HURON-CLINTON METROPOLITAN AUTHORITY
FLATROCK DAM 2008 REPAIRS

AS-BUILT ("A.B.") DRAWING NOTES	JRR	By	Appd.	01.10
Revision				MM.DD.YY
BID SET				05.08
OWNER REVIEW				03.08
QA/QC (95%)				02.08
ROAD COMMISSION SUBMITTAL (WCOPS)				01.08
REVISIONS PER MDO				12.13.07
PERMITS (90% SET)				10.31.07
60% REVIEW				07.07.10
Issued		By	Appd.	MM.DD.YY

SOIL EROSION CONTROL AND MISC. DETAILS

**RIGHT SIDE, LOCK
DEMOLITION PLAN**

Title
RIGHT SIDE, LOCK
DEMOLITION DETAILS

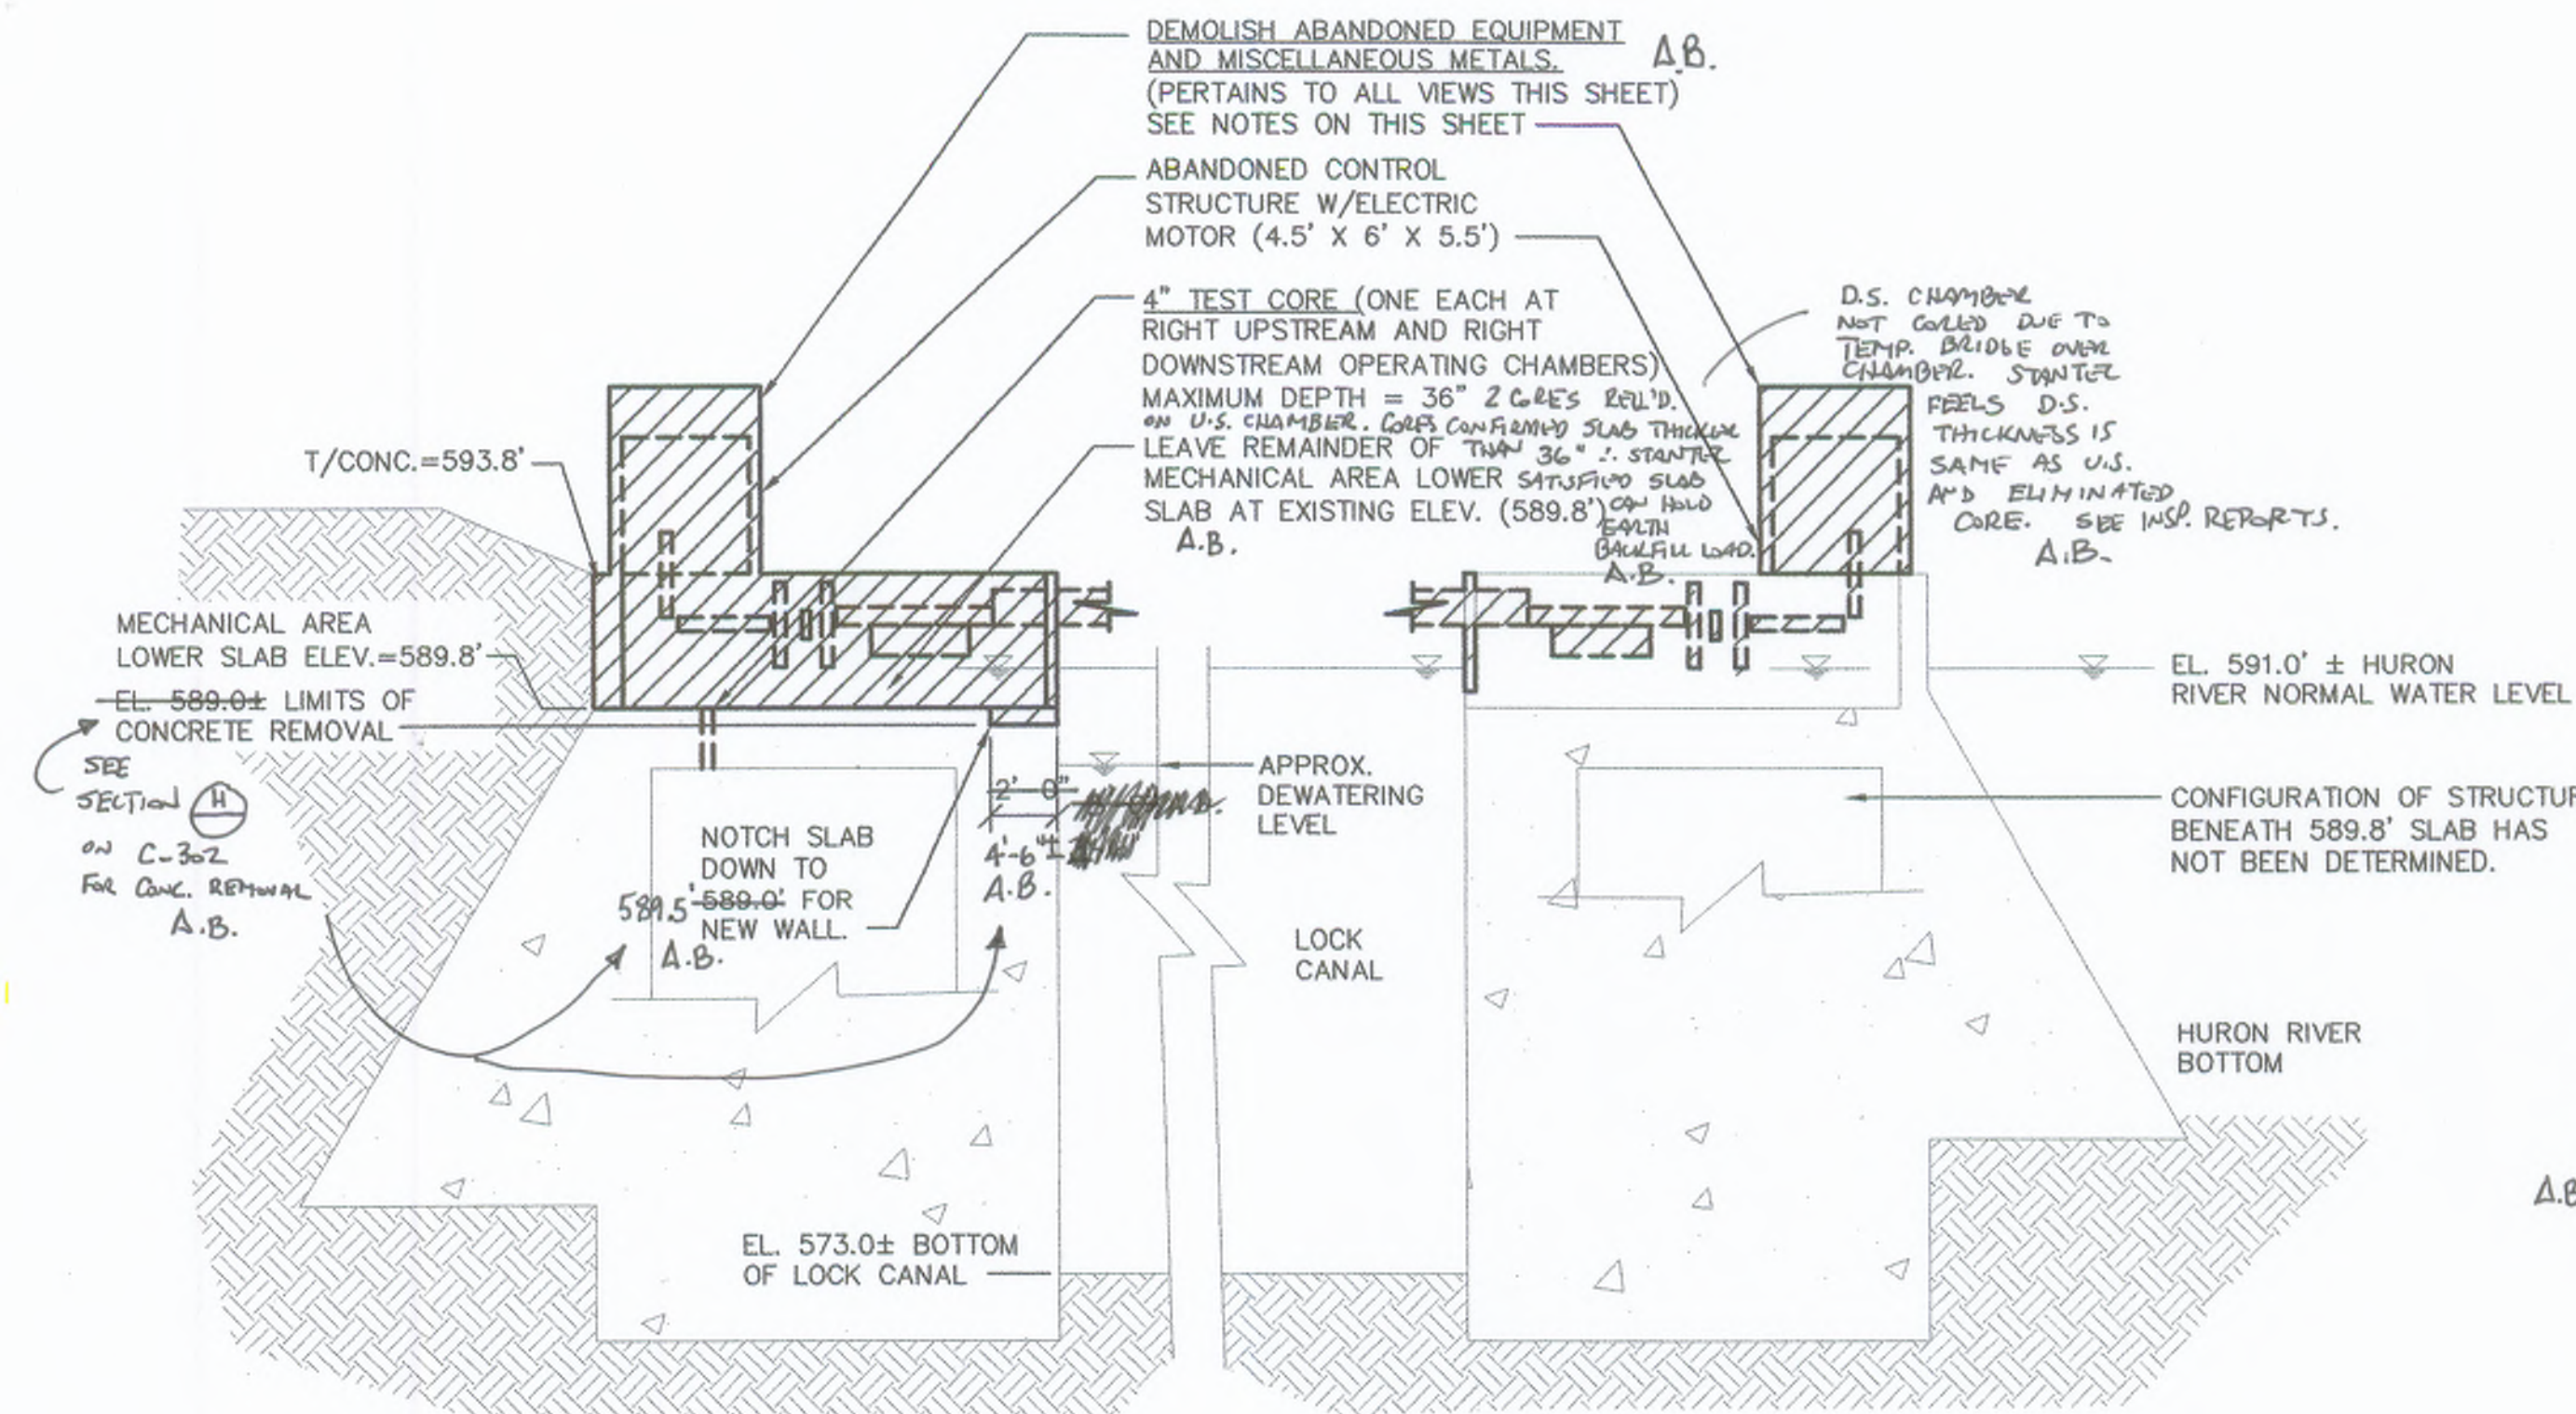
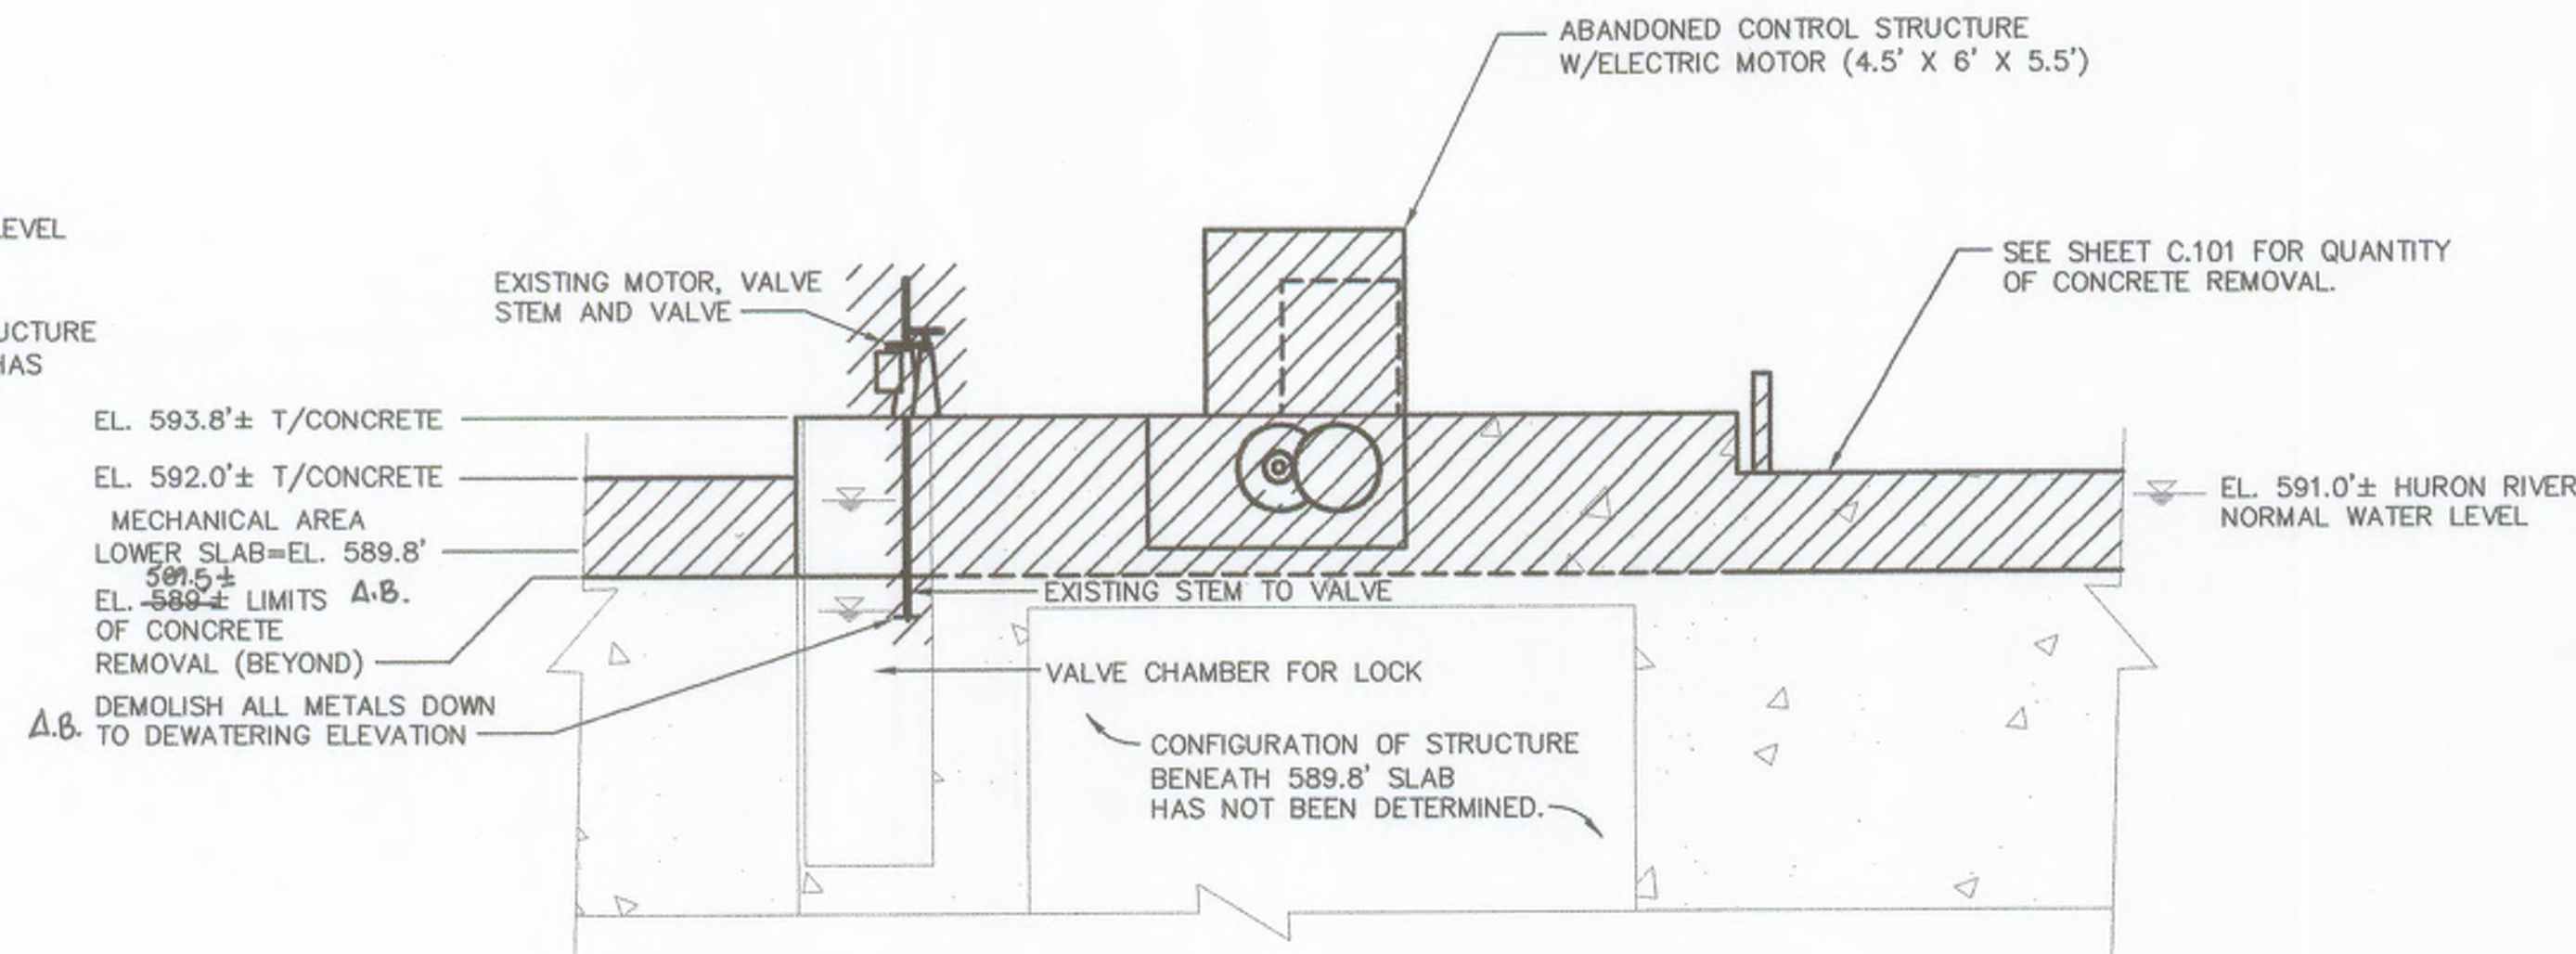
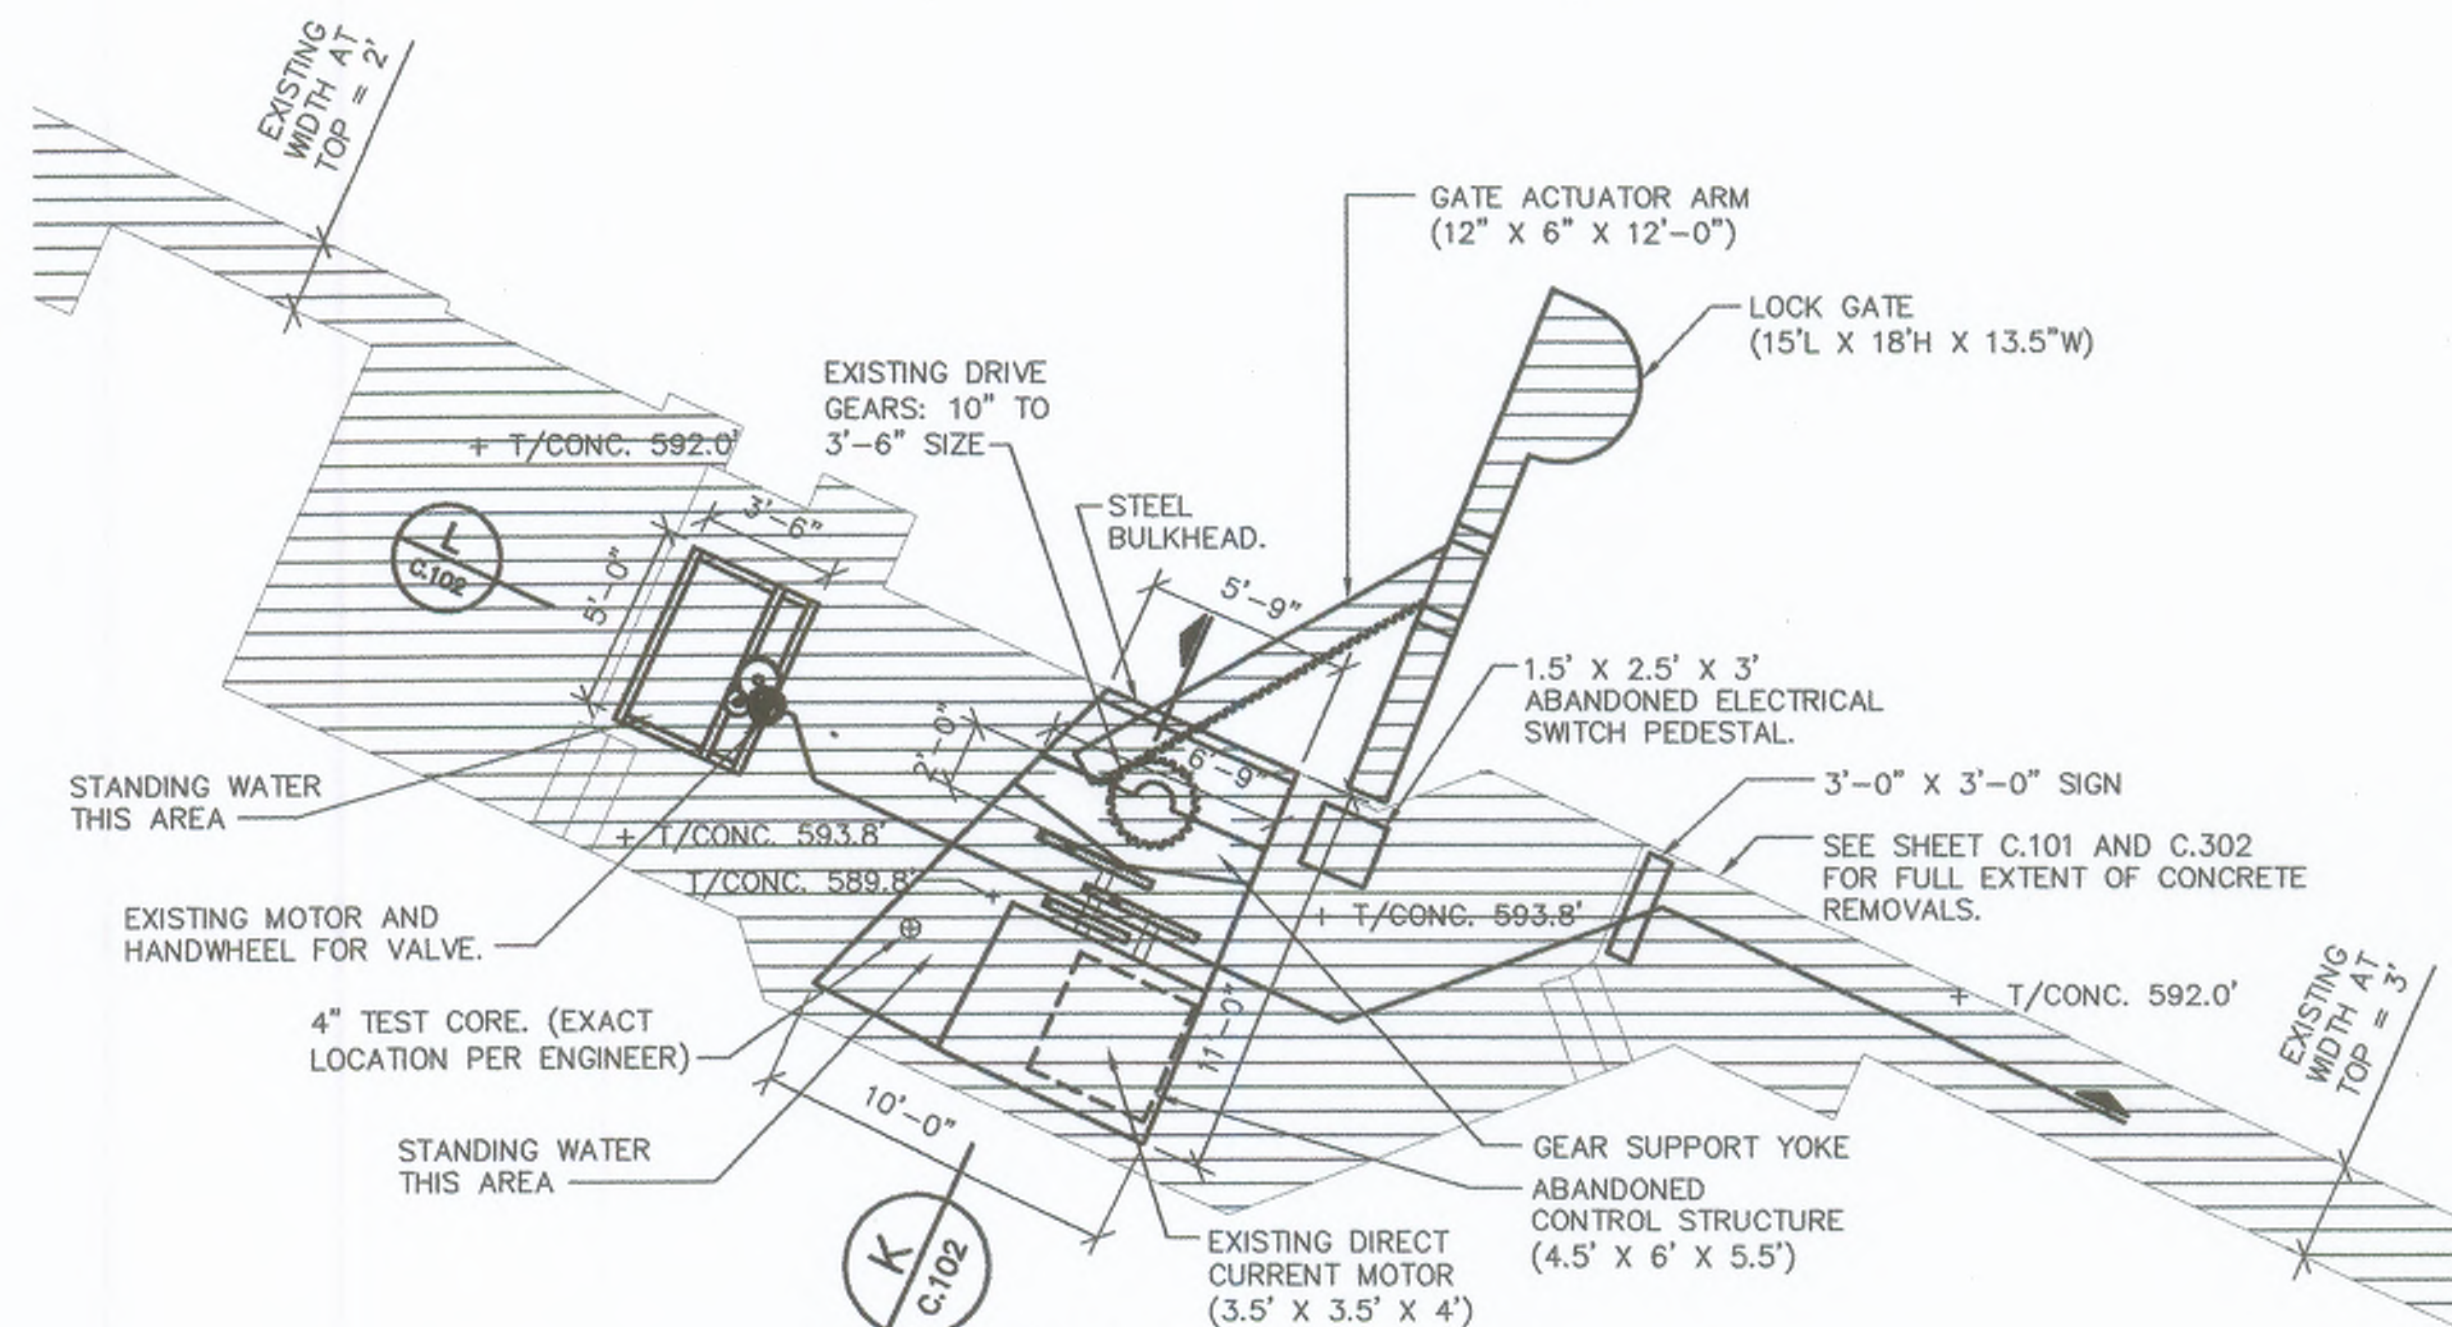
A.B. 1. DEMOLISH AND REMOVE ALL EQUIPMENT AND MISC. METALS IN THE AREAS SHOWN. THIS SHEET DEPICTS MOST OF THE SIGNIFICANT MECHANICAL EQUIPMENT THAT EXISTS AT THE LOCK CONTROL STRUCTURES. THE INTENT IS THAT ALL ABANDONED EQUIPMENT IN THE REMOVAL AREAS OF THE CONTROL STRUCTURES BE REMOVED AND DISPOSED OF BY THE CONTRACTOR. DIMENSIONS ARE SHOWN ONLY FOR THE PURPOSE OF CONVEYING THE APPROXIMATE SIZE OF THE REMOVALS.

2. IN BOTH STRUCTURES, REMOVALS SHALL INCLUDE ALL VISIBLE EQUIPMENT, GATE ACTUATOR ARMS, MOTORS, GEARS, DRIVE SHAFTS, LADDER RUNGS, SUPPORT STEEL, STEEL STRUCTURES AND APPURTENANCES FROM THE DEWATERING ELEVATION AND UP. A.B. THE LOCK GATES ON BOTH THE LEFT AND RIGHT SIDES SHALL BE REMOVED IN THEIR ENTIRETY (TO FULL DEPTH). A.B.

3. SUPPORT POINTS AND ANCHORAGES INCLUDING GATE PIVOTS AND OTHER METAL APPURTENANCES (INCLUDING THOSE BELOW WATER) REMAINING IN THE EXISTING CONCRETE SHALL BE CUT FLUSH SO AS TO AVOID SHARP OR JAGGED EDGES, SNARE POINTS OR OTHER HAZARDS. A.B. (LADDERS IN WELLS COULDN'T BE CUT FLUSH - WARNING) A.B.

GENERAL CONTRACTOR DEMO'D EQUIPMENT PRIOR TO ASBESTOS ABATEMENT WHILE JOB'S WORK WASN'T PRESENT, (AS SPEC'D.). B.C. BLAUGHT IN ABATEMENT CONTRACTOR AFTER BEING CHARGED FOR CLEAN-UP. - NEVER RECEIVED ABATEMENT RESULTS FROM B.C. DEBATE MANY ATTEMPTS. A.B.
